**WIGLEY RD. TRACT
RESIDENTIAL COMMUNITY
ZONING PLAN**

Z-56 2017-GIS

ZONING COMMENTS:

STAFF RECOMMENDATIONS

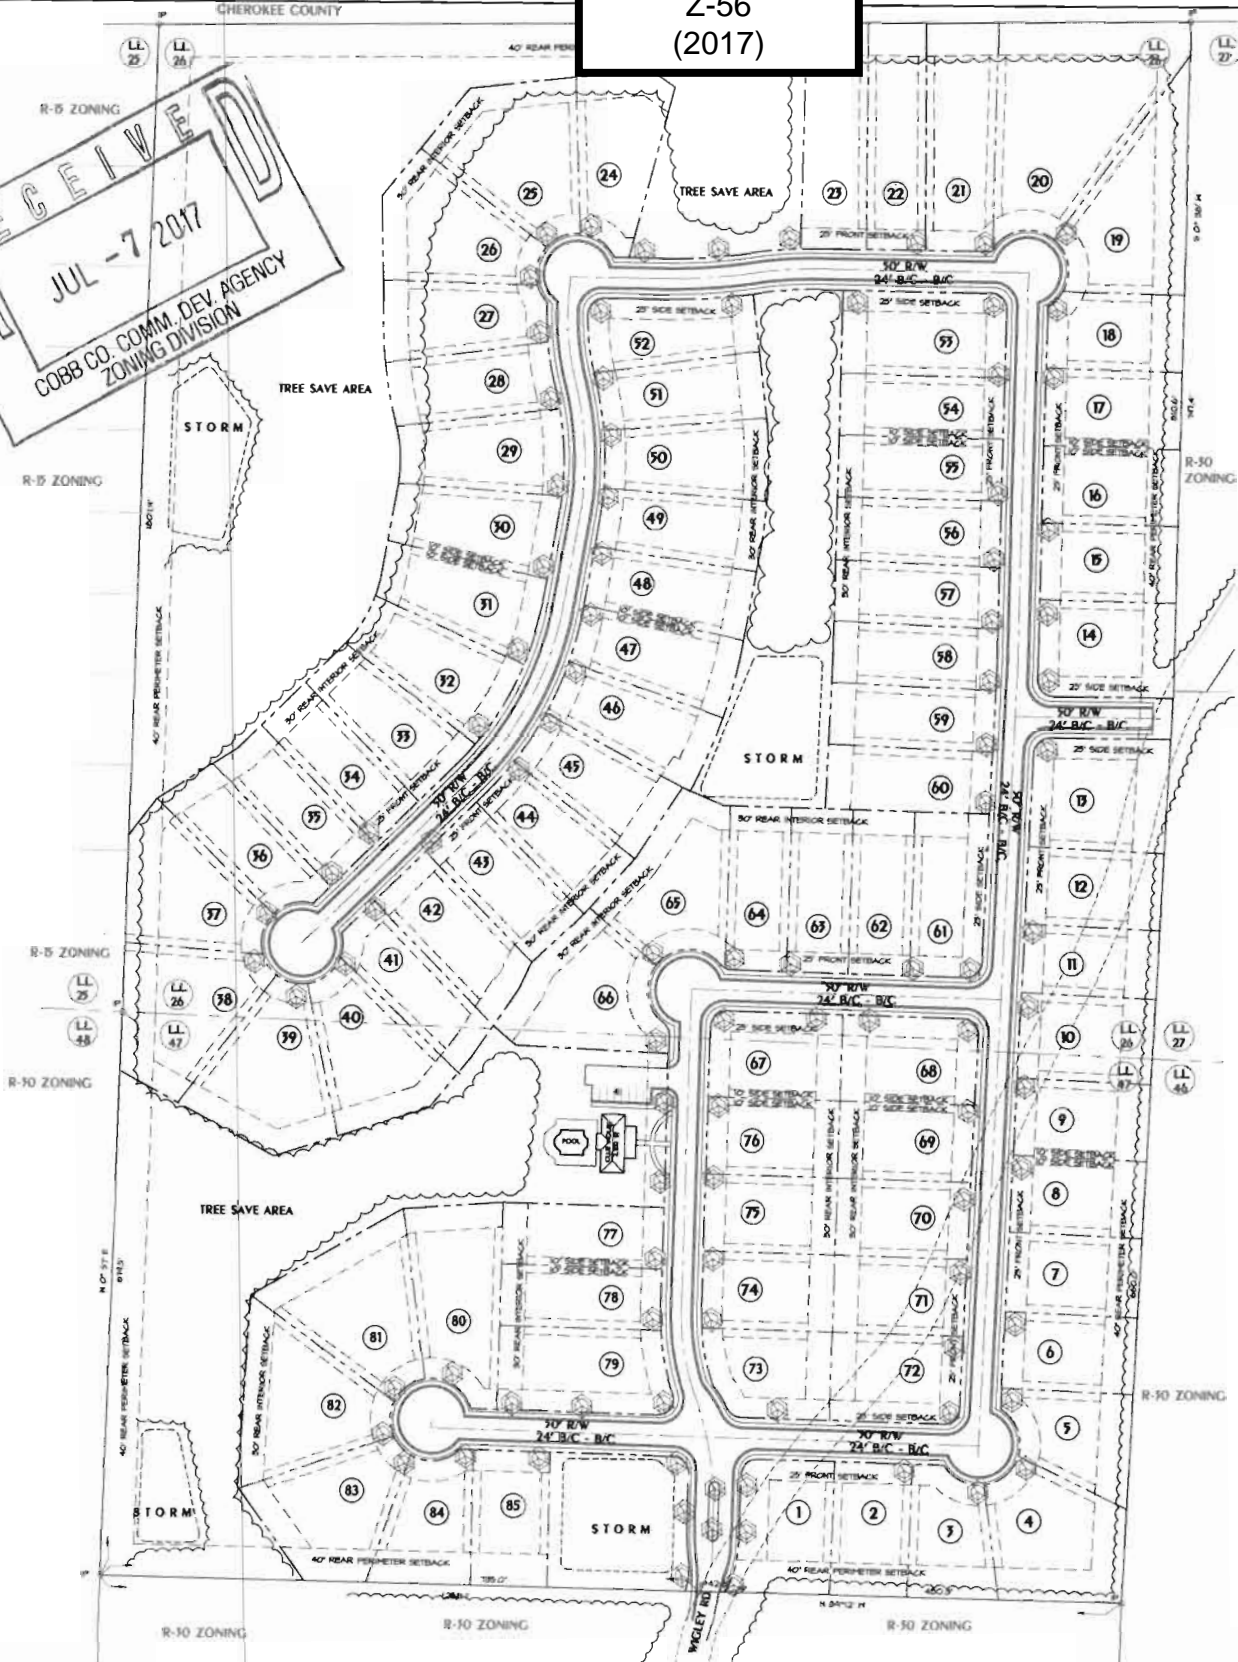
1. Waive the front setback on all lots from the required 35 feet to 25 feet; and
2. Waive the public road frontage on cul-de-sac lots from 50 feet to 38 feet.

1. This site is located on the northern portion of Wigley Road. The site lies on a steep ridgeline and drains in three directions. The majority of the site (40%) drains to the south roughly parallel to Wigley Road. Approximately 35% of the site drains to the northeast along Wigley Road into Cherokee County. The remaining 25% of the site drains to the west into and through the adjacent Falcon Crest Subdivision. The site is predominately wooded with steep slopes ranging from 12 to 40%. The site layout needs to be sensitive to the steep topography. A preliminary rough grading plan should be provided to verify feasibility of the proposed layout.

2. Stormwater management for the site will be provided by multiple onsite detention ponds. The pond locations may need to be adjusted to limit grading required and to adequately control runoff from the development.

3. As indicated in the Downstream Conditions comments above, there is an existing lake located approximately 300 feet downstream. A pre- and post-development sediment study will be required to document any sediment impacts to this lake. Elevated onsite erosion control measures will be required due to the steepness of the site.

4. A downstream headwater pool analysis will be required for the existing receiving culvert in Falcon Crest S/D to verify no adverse impact. The basement at 2254 Hawk Trace is located significantly below the low point of the road.

Wigley Drive is classified as a local and according to the available information the existing right-of-way does not meet the minimum requirements for this classification.

The existing Wigley Road right-of-way will need to be abandoned prior to Land Disturbance Permit.

- B. It is Staff's opinion that the applicant's rezoning proposal may have an adverse effect on the usability of adjacent or nearby property. The property is severely impacted by steep slopes and staff is concerned about erosion issues downstream and downslope. Other developments, zonings and densities in the area include: Jefferson Township Phase Five (zoned PD at approximately 0.32 units per acre); The Summit at Sweat Mountain (zoned R-30 at 0.72 units per acre); Bluffs at Jamerson (zoned R-20 at approximately 1.60 units per acre overall for Phases 1 and 2); Hampton Ridge Unit IV (zoned R-15 at 1.65 units per acre); and Falcon Crest Subdivision Unit III (zoned R-15 at approximately 2.50 units per acre).

- E. It is Staff's opinion that there are existing and changing conditions affecting the use and development of the property which give supporting grounds for denying the applicant's rezoning proposal. The surrounding area of Wigley Road is zoned as R-30. The steep slopes on the property, if developed in a more intense manner, can impact surrounding and downstream properties. Larger lot R-30 development would be preferable due to less grading activity. Staff is aware that other neighborhoods in this area have caused drainage and sedimentation problems due to smaller lot sizes on steep slopes.
